Exhibit 20

SUBJECT: TRC COMMENTS FOR THE FARM AT MILL CREEK, PL2018-0004

THE FARM AT MILL CREEK
PRELIMINARY PLANS

Binding Site Plan

PRELIMINARY SITE PLAN

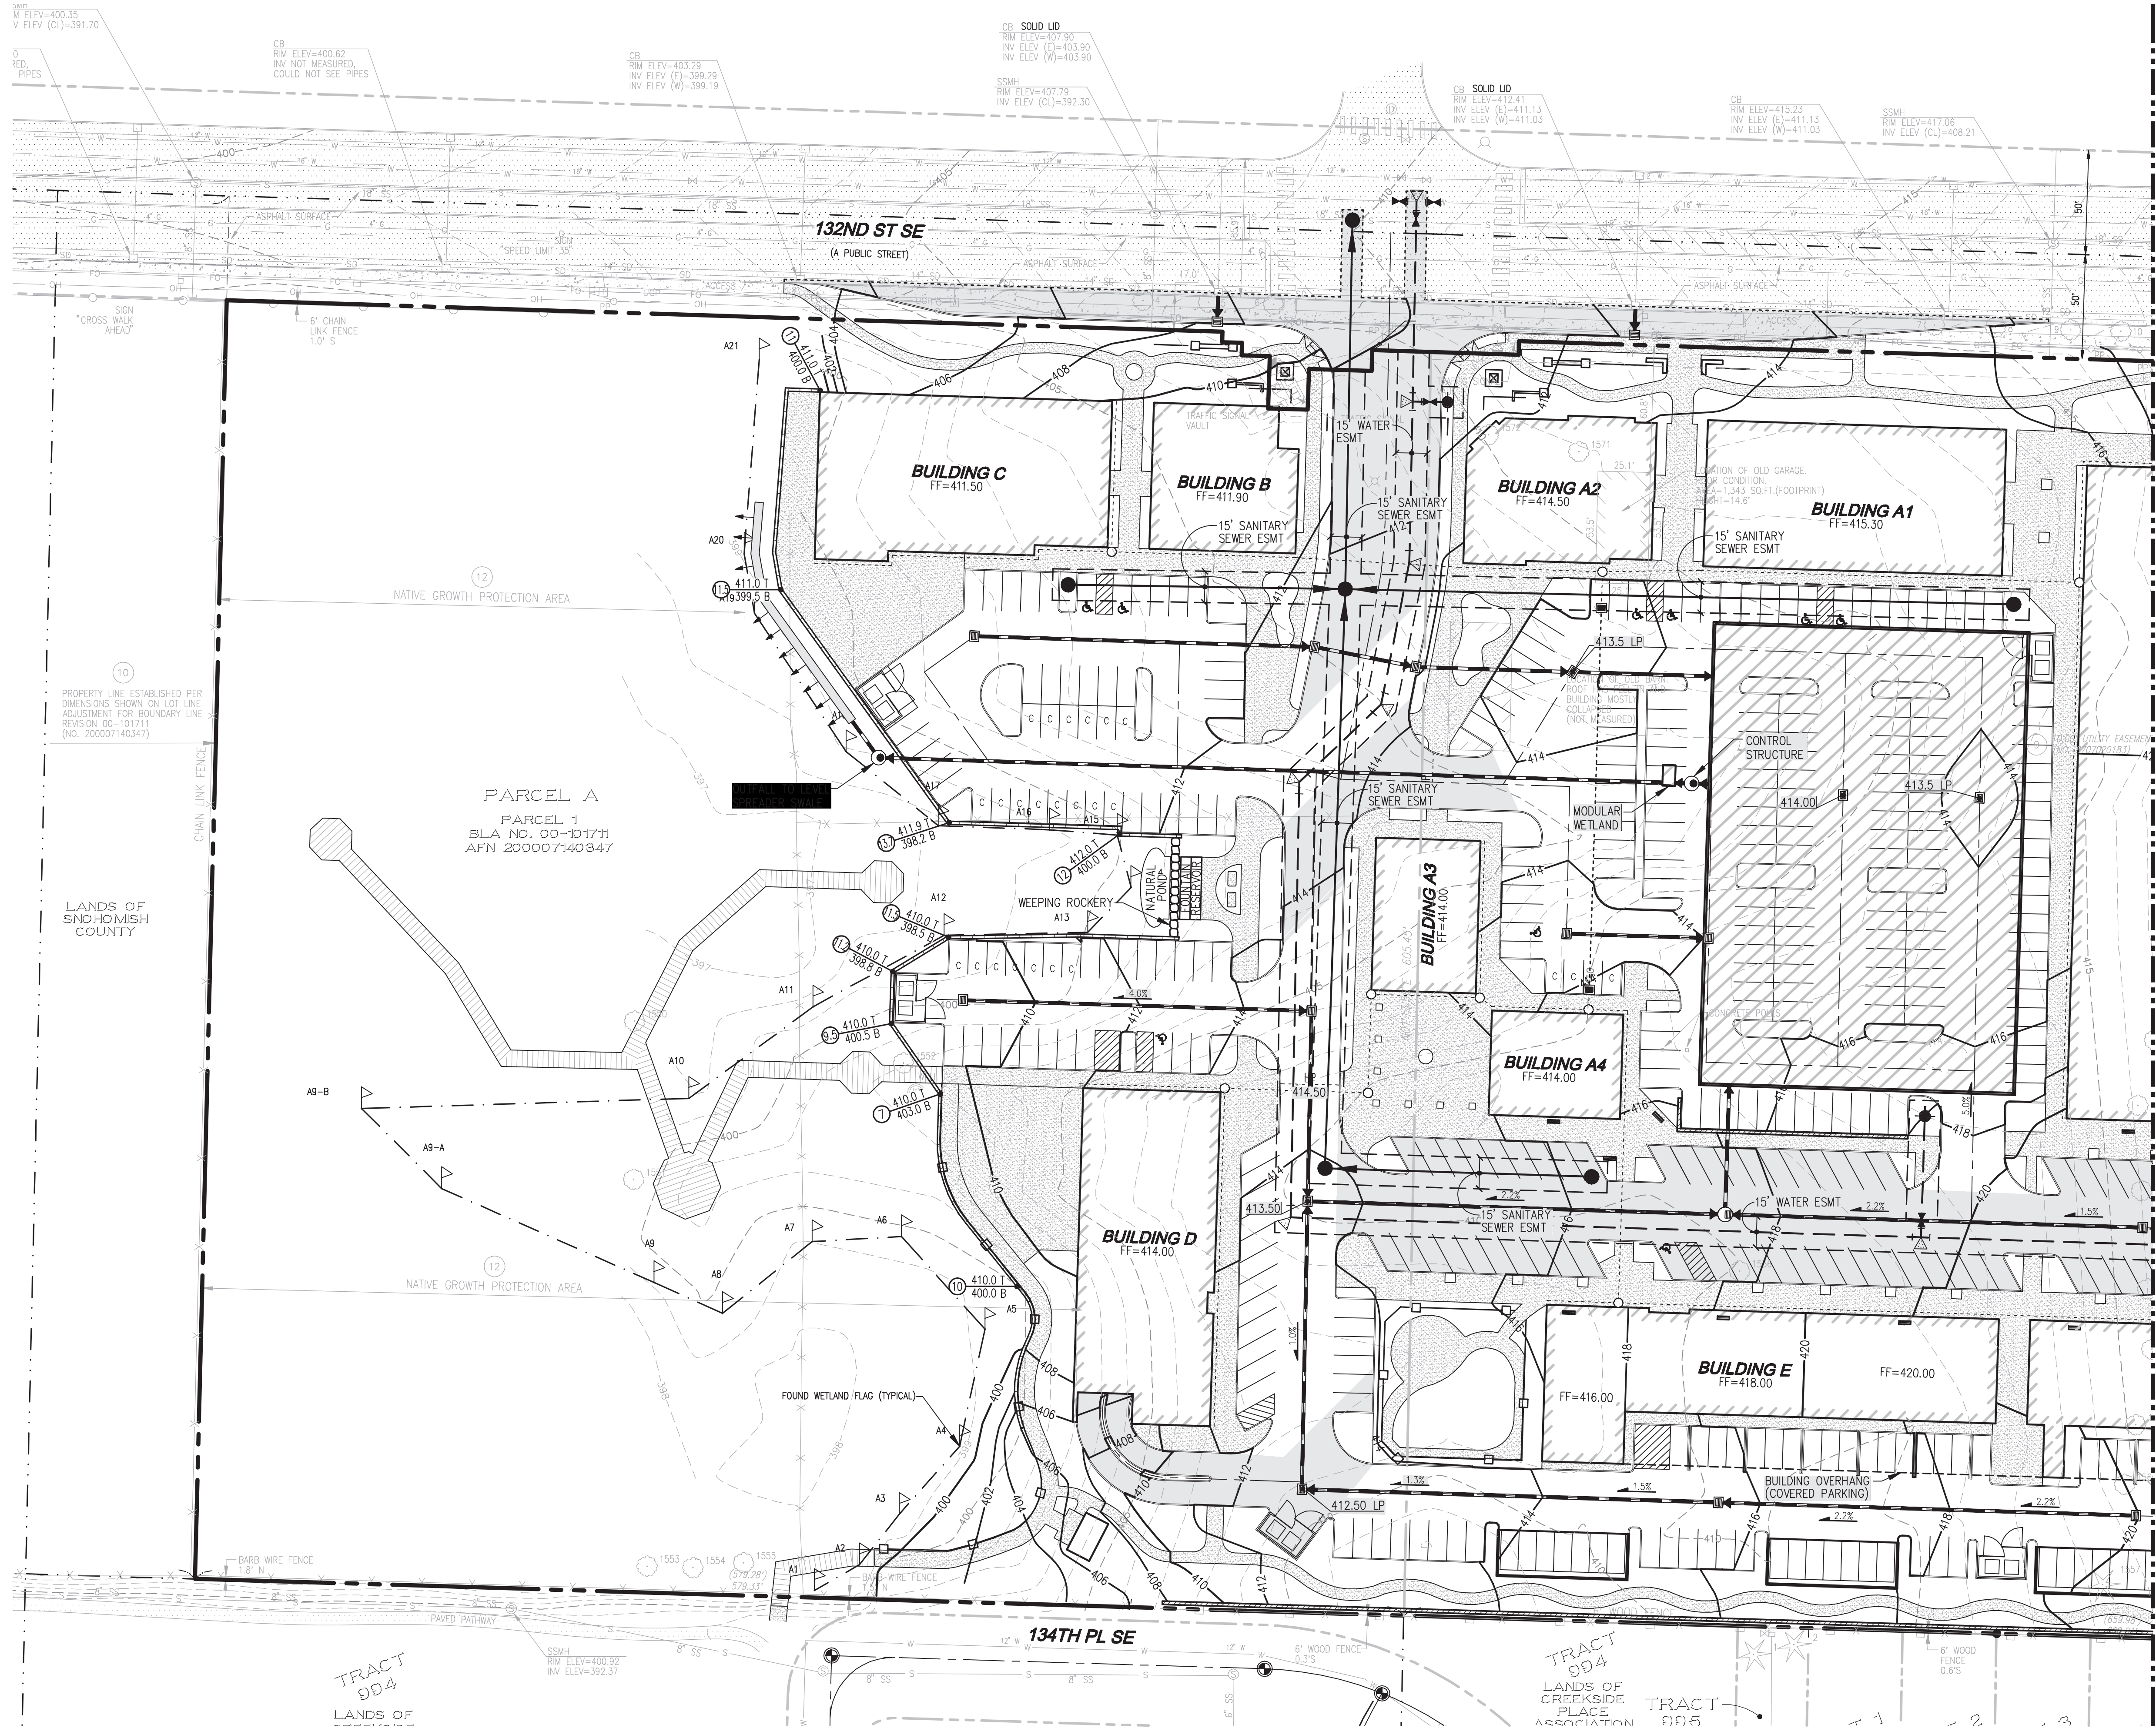
Show 1 landscape island every 10 stalls per MCMC 17.34.040.H.

Revise Wetland Buffer and/or mitigation plan to be compliant with MCMC18.06 per ESA Critical Areas Review Letter dated 4-25-18.

35 foot
Roadway
Buffer is to
be retained
in a
separate
tract, per
MCMC

Load and unload zone locations?
